MICHIGAN
STATE HIGHWAY DEPARTMENT

INTEROFFICE COMMUNICATION

SUBJECT: American Steel and Wire Company alternate 3" x 12" mesh for
concrete pavements
Report No. 168 Research Project 52 G-60

Construction practice adjacent to joints, showing how concrete must pass freely through mesh without segregation to insure satisfactory work.

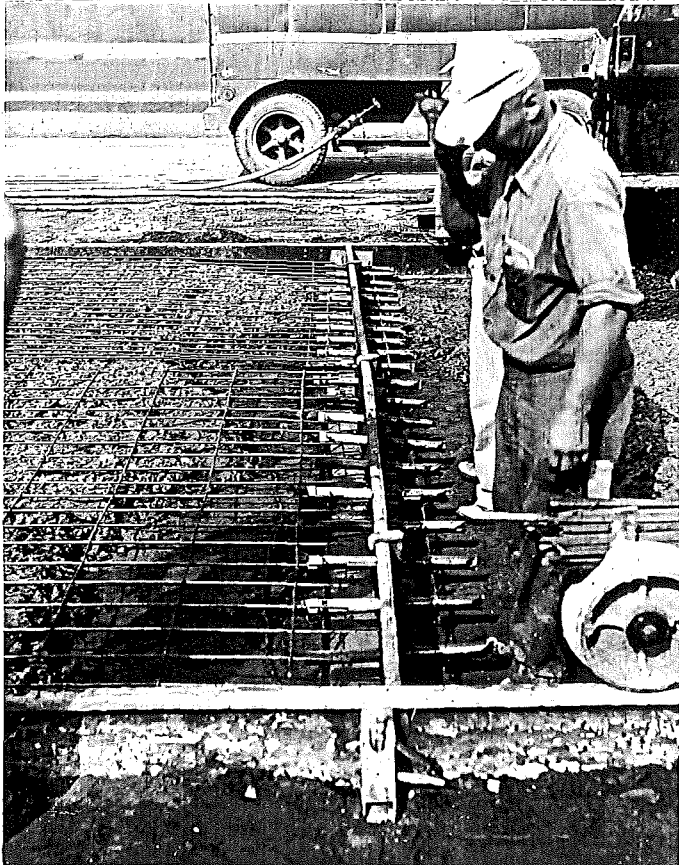
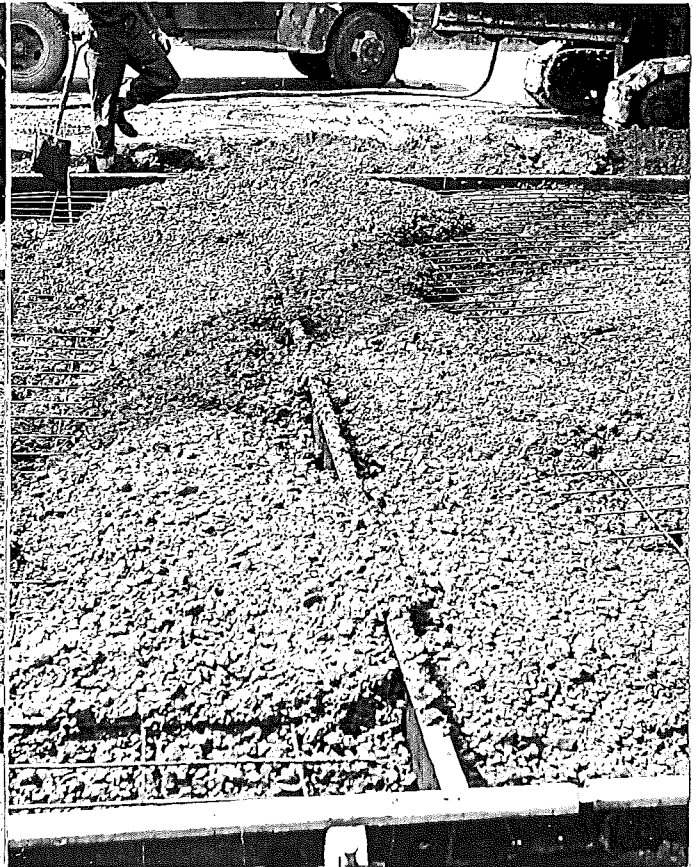
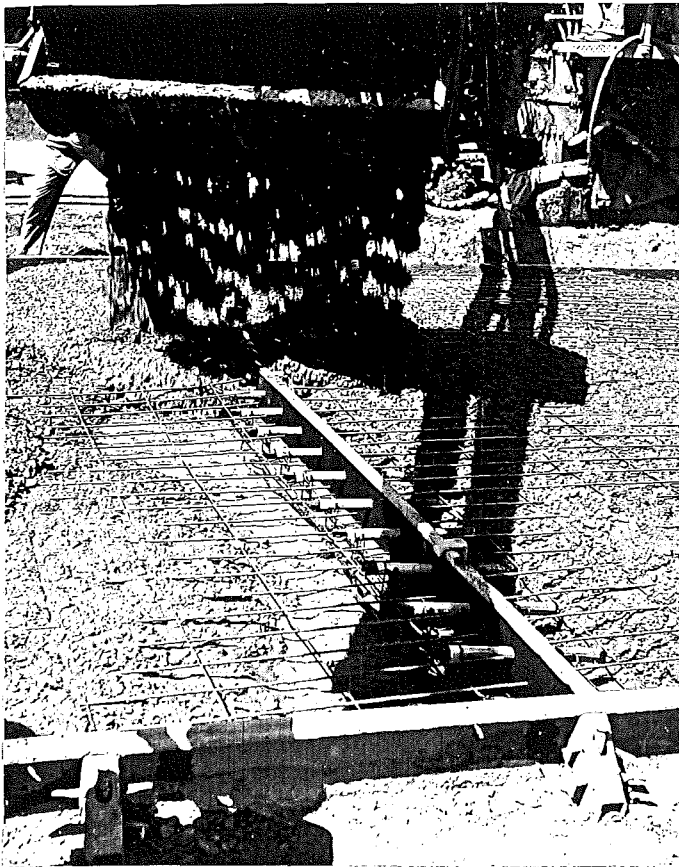
For Item 2, there is no question but that the closer spacing would provide better distribution of steel; but on the other hand, the placing of the bars at three-inch centers introduces construction factors which cannot be ignored. As shown in the attached photographs, which illustrate typical concreting practice at joint installations, the narrow spacing of the longitudinal wires will make it extremely difficult to force the concrete down through the mesh and completely fill the unpoured areas adjacent to the joints. Furthermore, if the first layer of concrete was not screeded perfectly, as is often the case, it would be more difficult to force the mesh into place through tramping by workmen.

The above, in turn, would necessitate closer supervision by paving inspectors.

In view of these facts, it is our firm opinion that such a mesh spacing should not be accepted.
